Proposed design changes following consultation:

Proposed design changes following consultation:

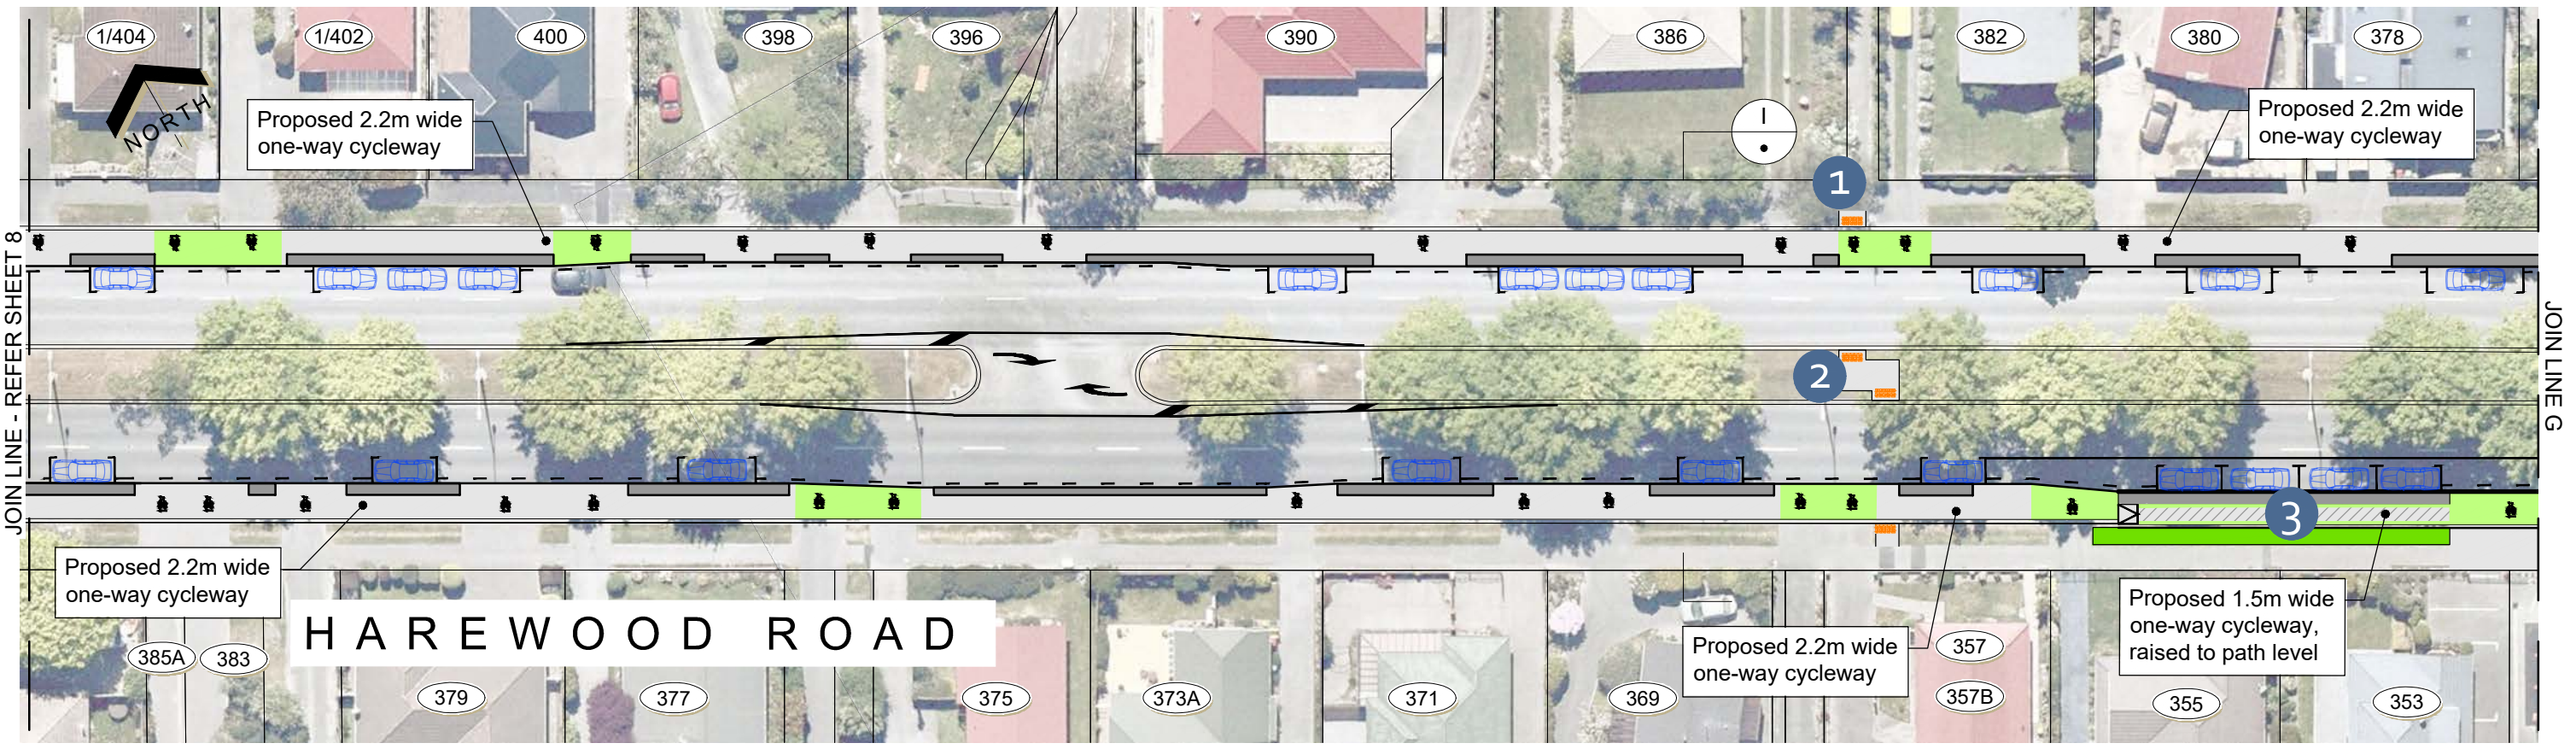
- Proposed design changes following consultation:**
- 1 A direct crossing to the cycleway from the alleyway between No. 382 and 386 Harewood Road is added.
 - 2 A pedestrian crossing point is added to the central median.
 - 3 The cycleway outside the Charity Hospital is realigned, narrowed and raised to footpath height. The existing driveways are also widened.
 - 4 A shared path area with access to Leacroft Street improves the connection on and off the cycleway to the surrounding area. Cycle stands are added near the playground on Leacroft Street.

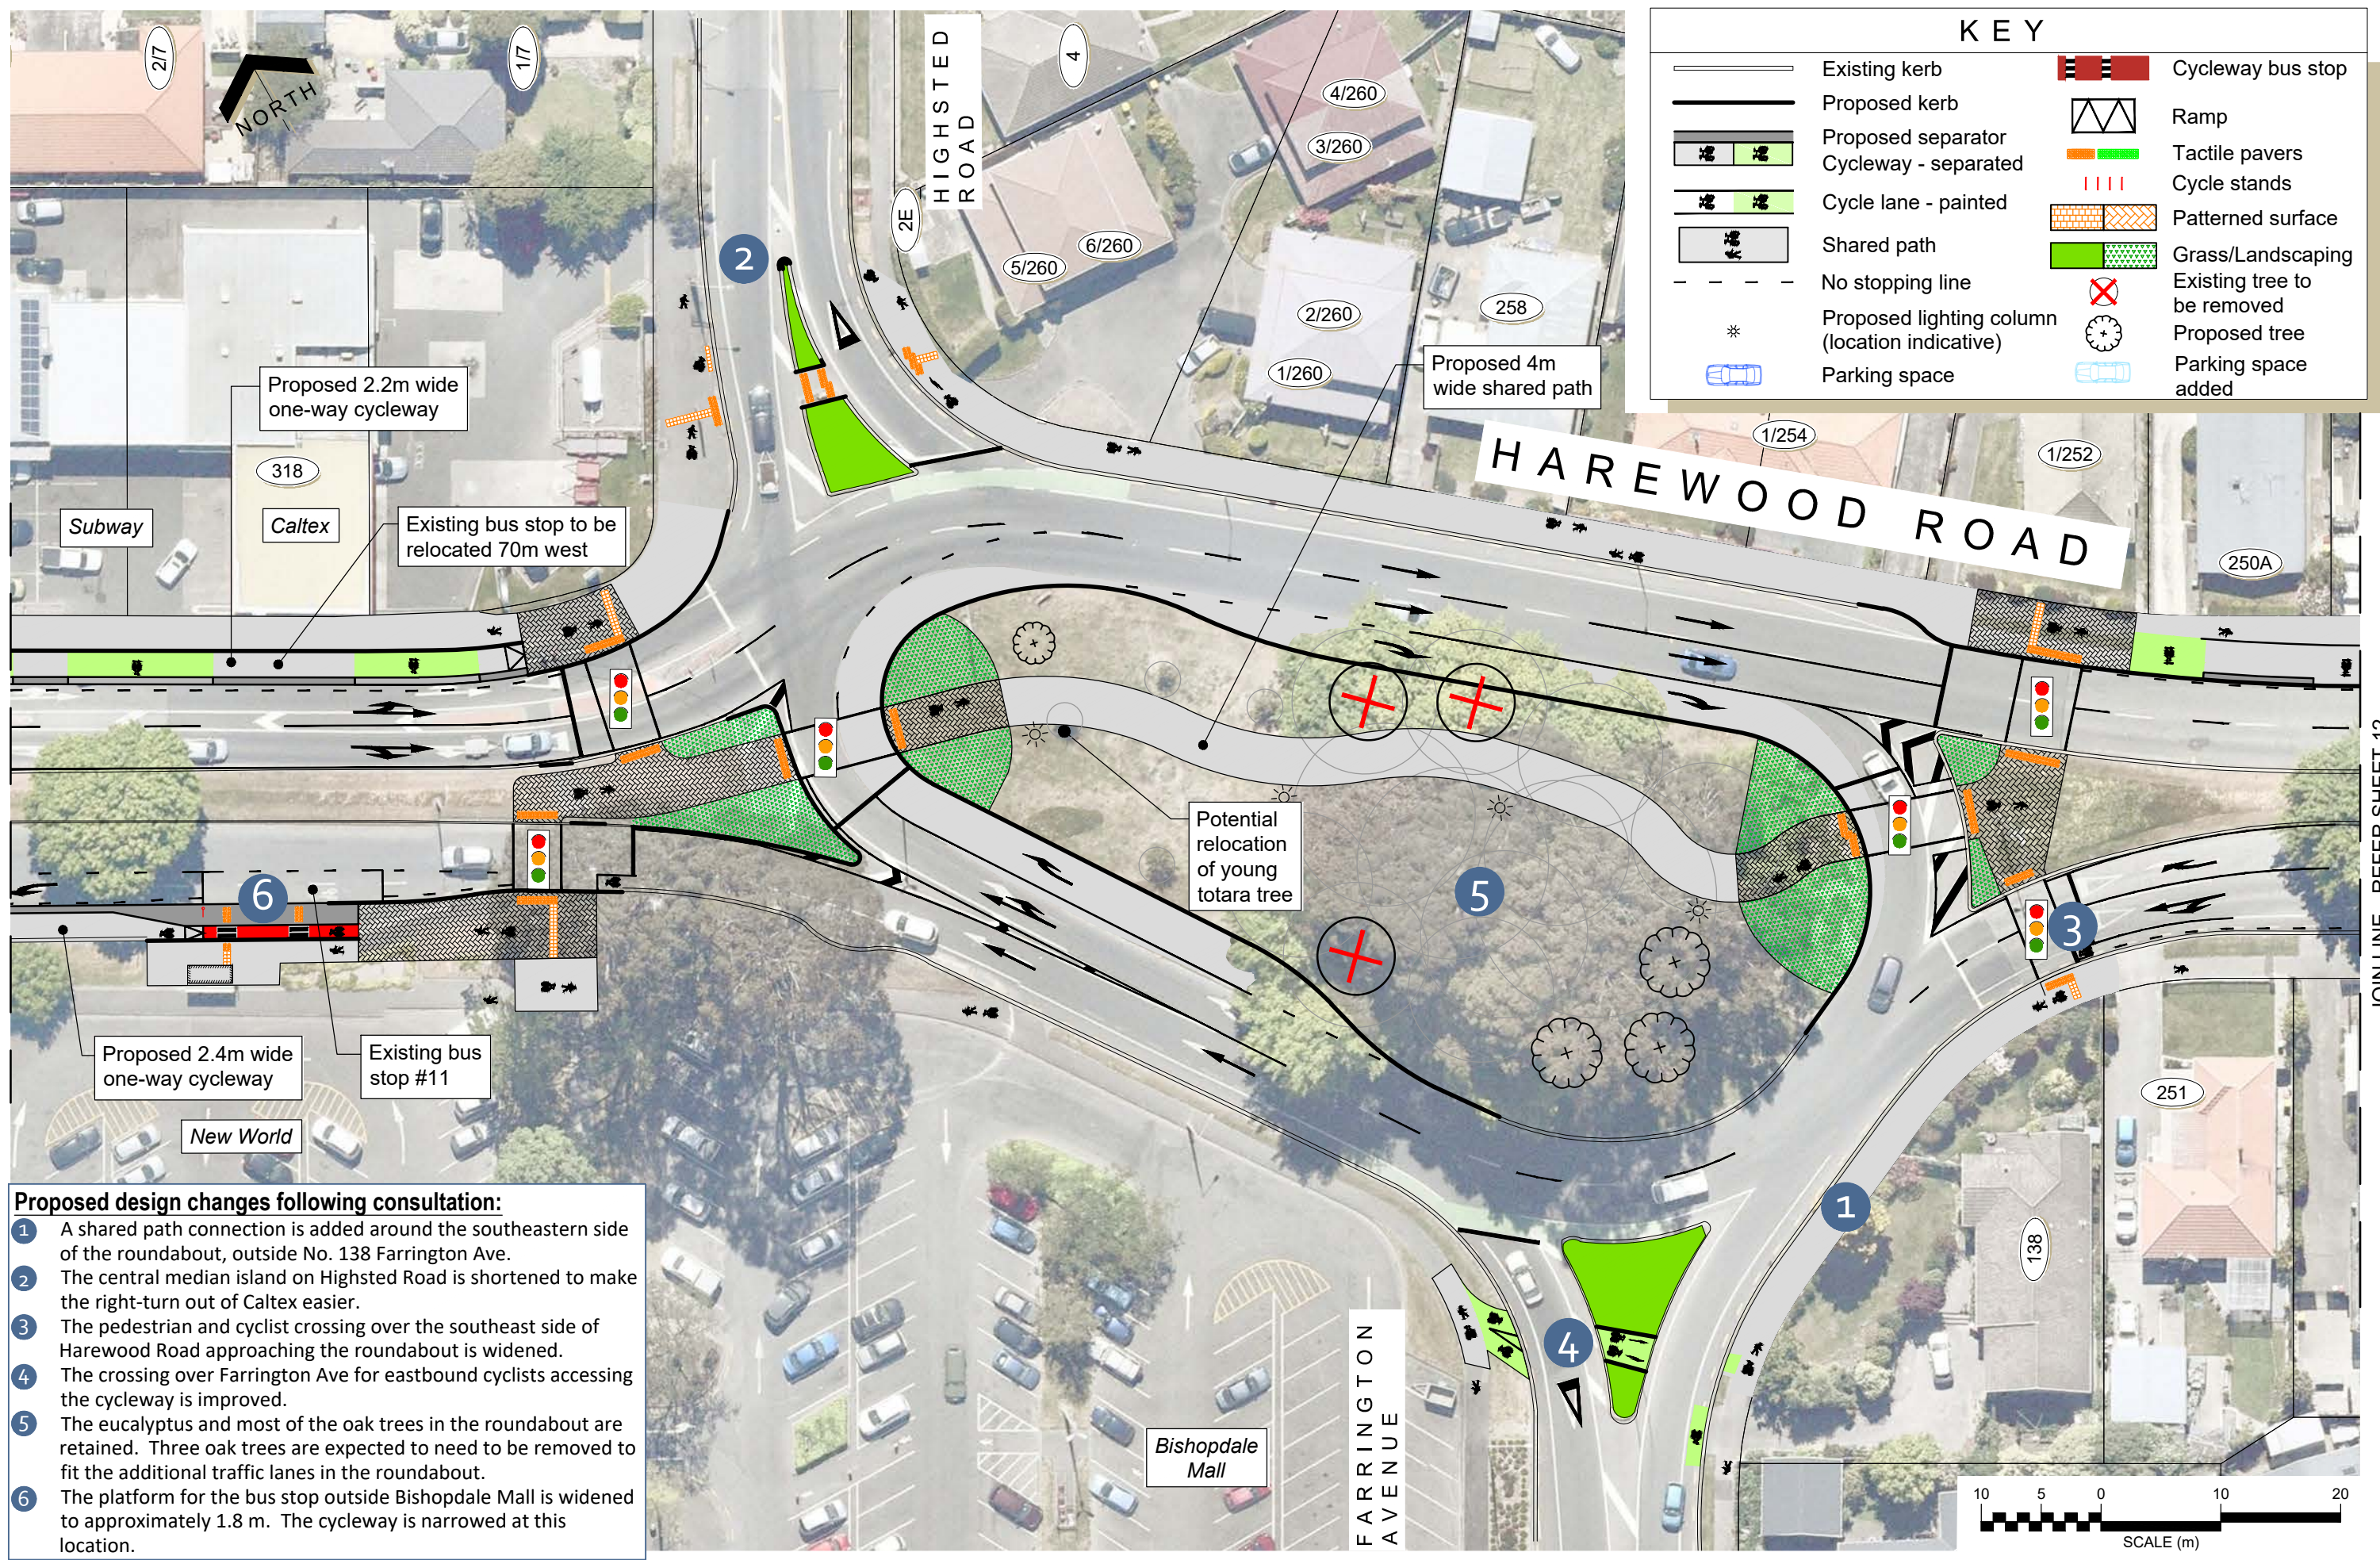
- Proposed design changes following consultation:**
- 1 The maintenance gate into the eastern side of Bishopdale Park is widened.
 - 2 An additional on-street parking space is provided outside No. 338/336 Harewood Road.
 - 3 The crossing through the central median is widened to make it easier to use.
 - 4 A shared path area with access to Cotswold Avenue improves the connection on and off the cycleway to the surrounding area.
 - 5 The platform for the bus stops outside Bishopdale Park, No. 364 and No. 332 Harewood Road are widened to approximately 1.8 m. The cycleway is narrowed at these locations.
 - 6 Cycle stands are added near the elephant slide.

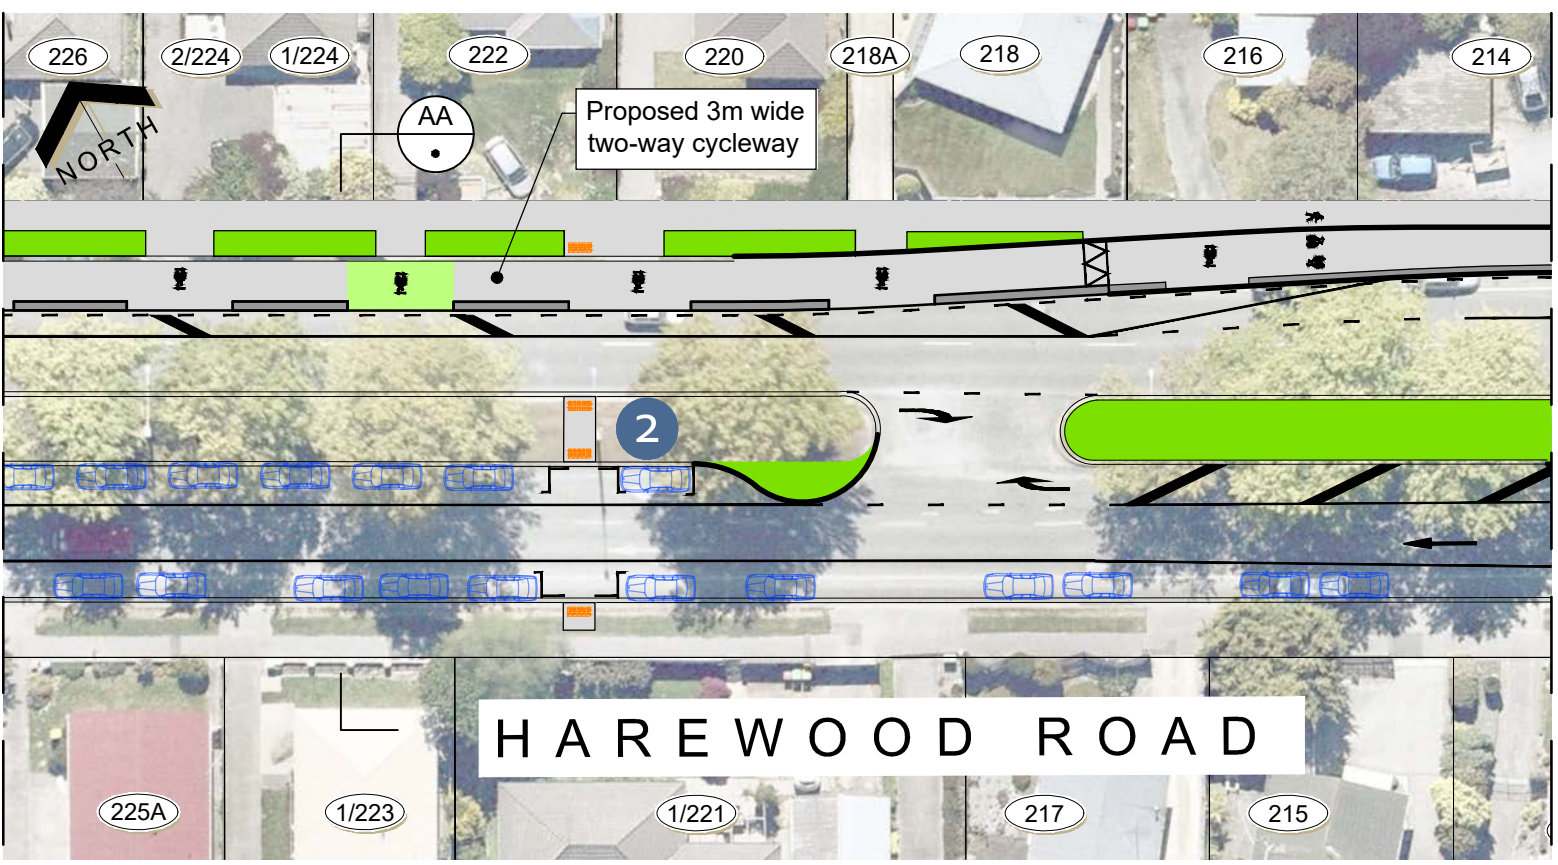
- Proposed design changes following consultation:**
- 1 A shared path connection is added around the southeastern side of the roundabout, outside No. 138 Farrington Ave.
 - 2 The central median island on Highsted Road is shortened to make the right-turn out of Caltex easier.
 - 3 The pedestrian and cyclist crossing over the southeast side of Harewood Road approaching the roundabout is widened.
 - 4 The crossing over Farrington Ave for eastbound cyclists accessing the cycleway is improved.
 - 5 The eucalyptus and most of the oak trees in the roundabout are retained. Three oak trees are expected to need to be removed to fit the additional traffic lanes in the roundabout.
 - 6 The platform for the bus stop outside Bishopdale Mall is widened to approximately 1.8 m. The cycleway is narrowed at this location.

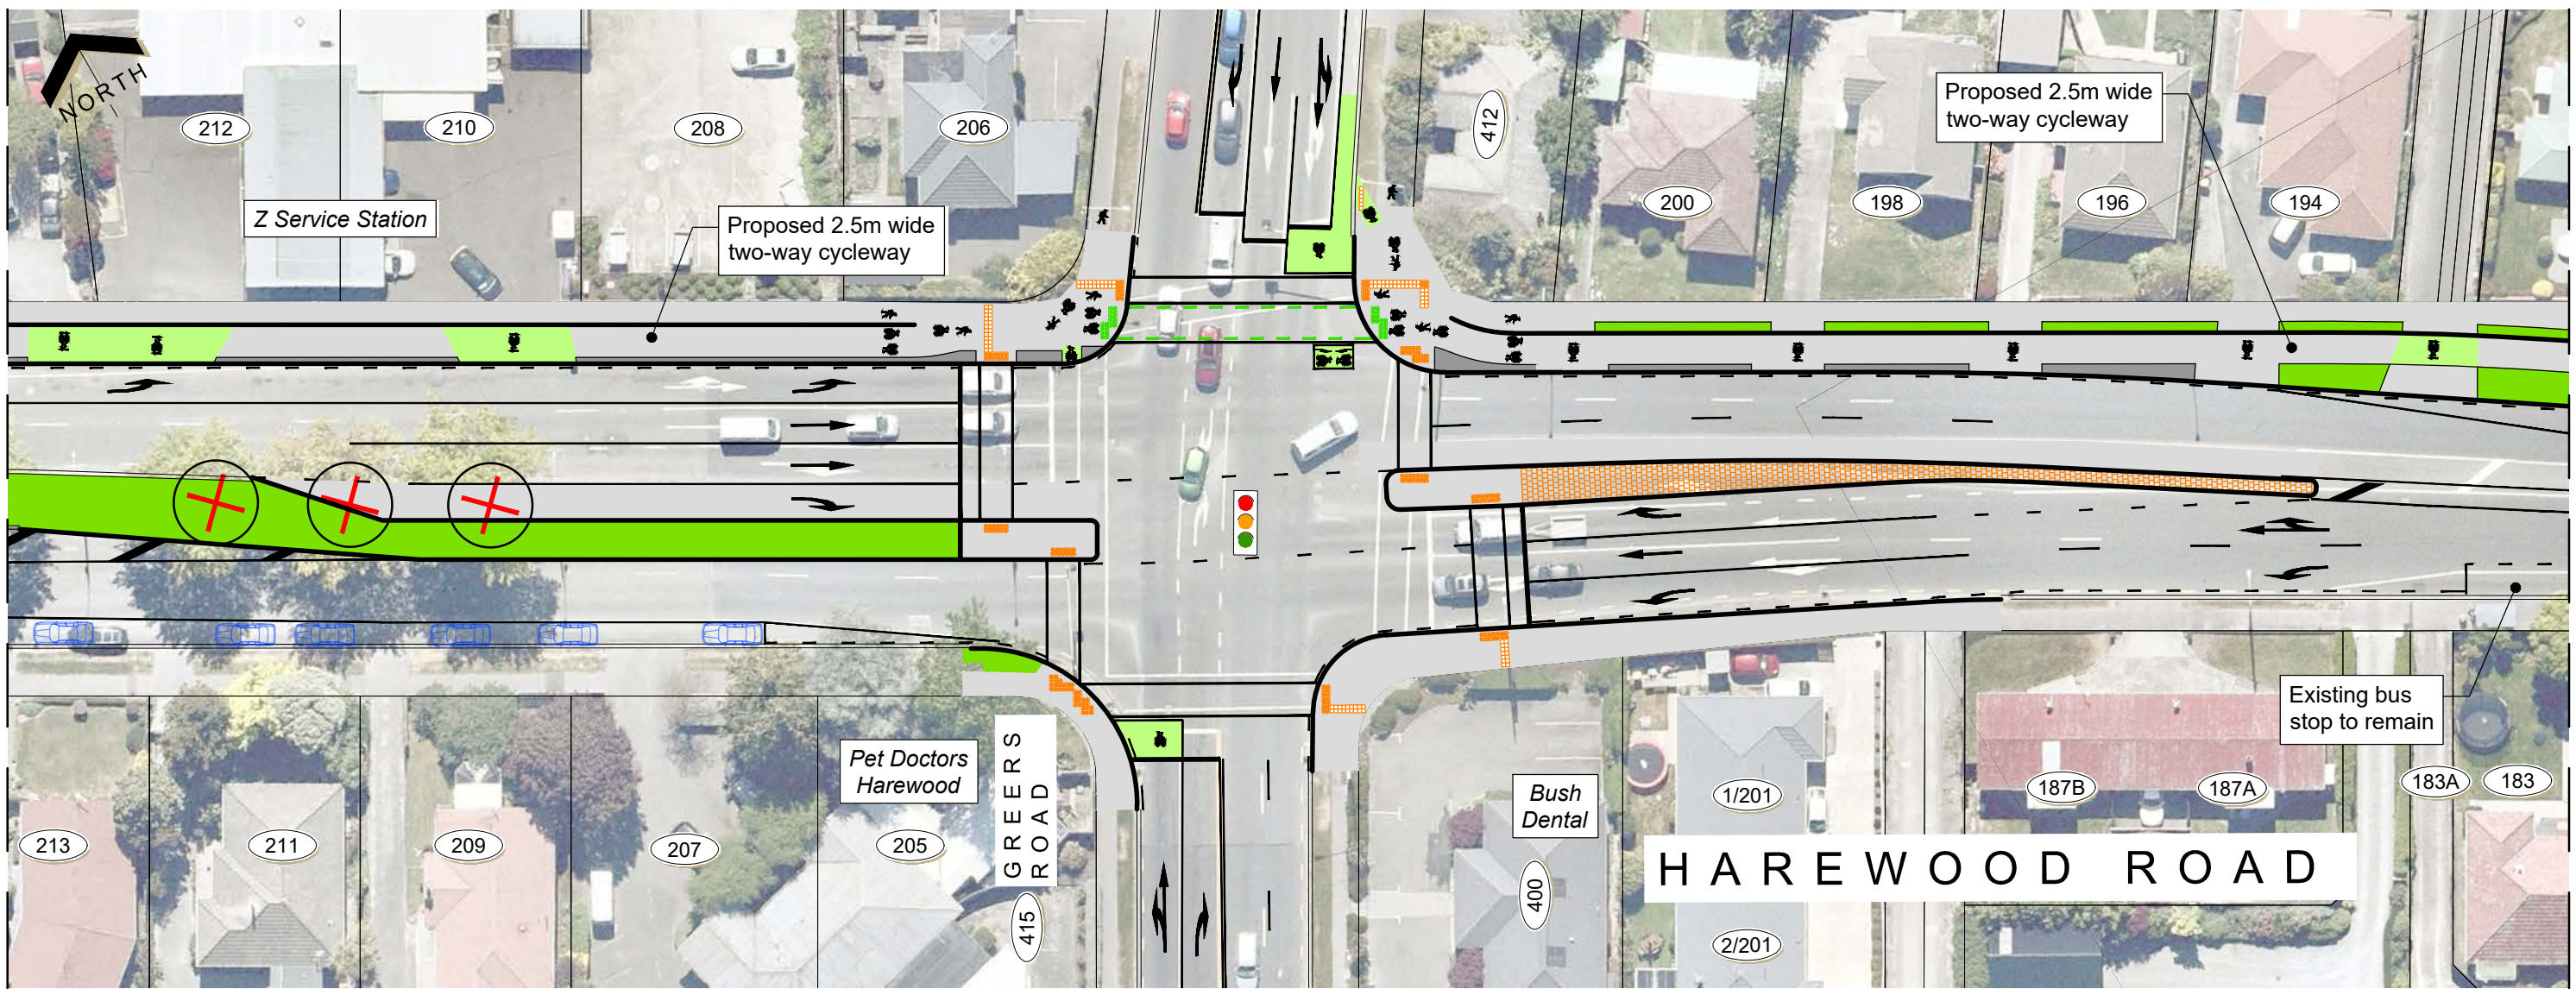
- Proposed design changes following consultation:**
- 1 A crossing point through the central median is added outside Bethesda Rest Home.
 - 2 A crossing through the central median outside No. 221/222 is provided to access the on-street parking adjacent to the median.
 - 3 A kerb buildout adjacent to the central median is added at the end of the on-street parking.
